DOCUMENT CHANGE REQUEST

DCR number 252	Changes required for: General	Originator: S JEFFERY
Date: 2006/04/04	Date sent: 2006/04/04	Organisation:
Status: IMPLEMENTED

Title:	Transistors Low Power PNP, based on type 2N2907A		
Number:	5202/001	Issue:	1

1.6 PHYSICAL DIMENSIONS AND TERMINAL IDENTIFICATION

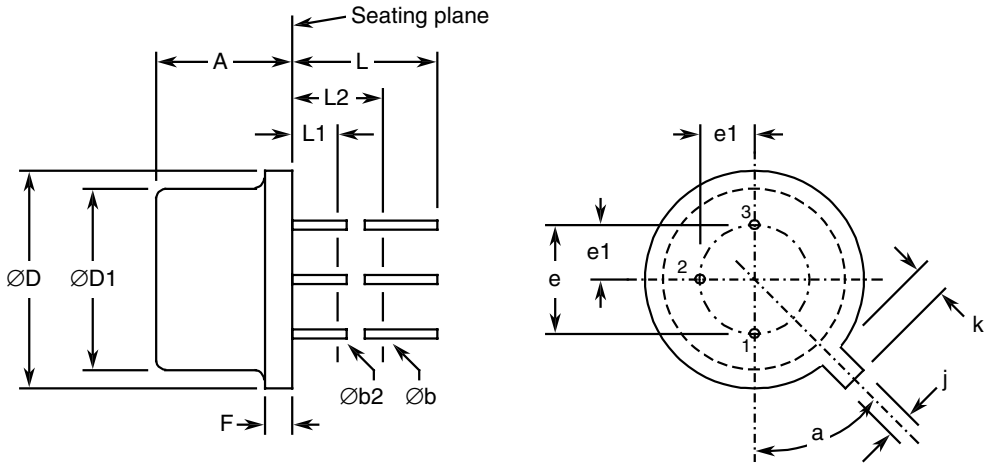
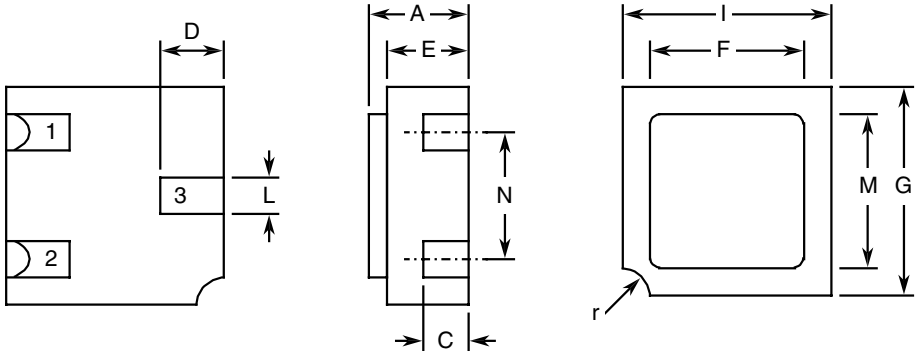
6. Para. 4.3.2 Weight requirements moved to Component Type Variants table.
7. Figure 2 re-named .Physical Dimensions and Terminal Identification. and amended to reflect the TO-18 and CCP packages currently supplied.

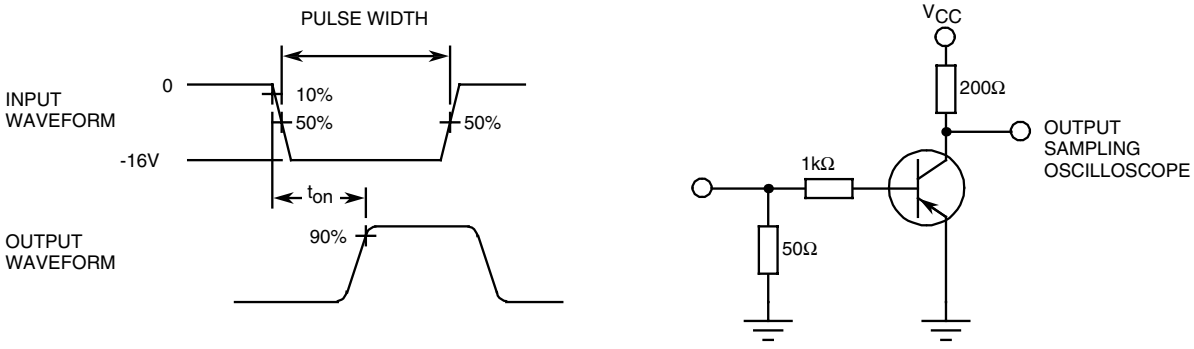
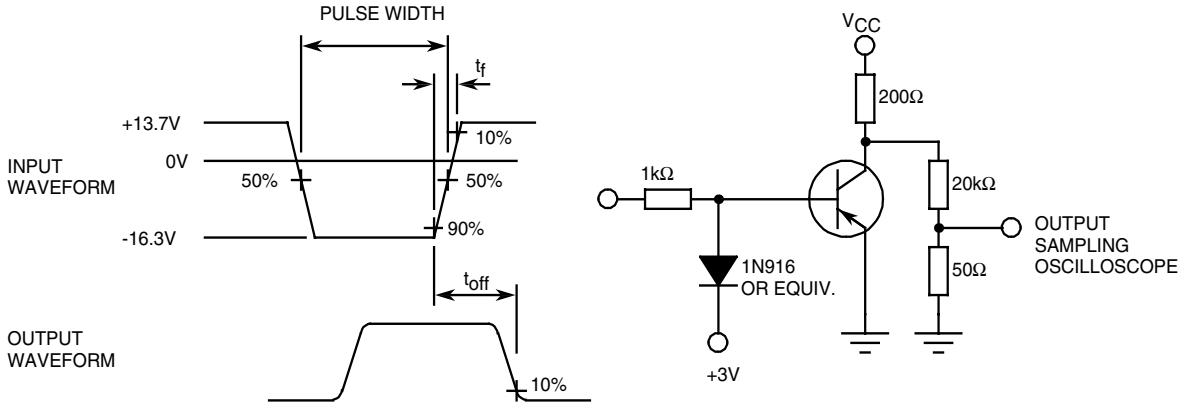
14. Table 2 and Figure 4: The Switching Times characteristics have been amended to reflect the new format.
15. Table 3, High Temperature Electrical Measurements: Sense of the specified limit corrected to minus (i.e. .10µA). 100% inspection has been replaced by a sample of 5 components with 0 failures, or 100%, in line with the new Generic 5000 Issue 3.
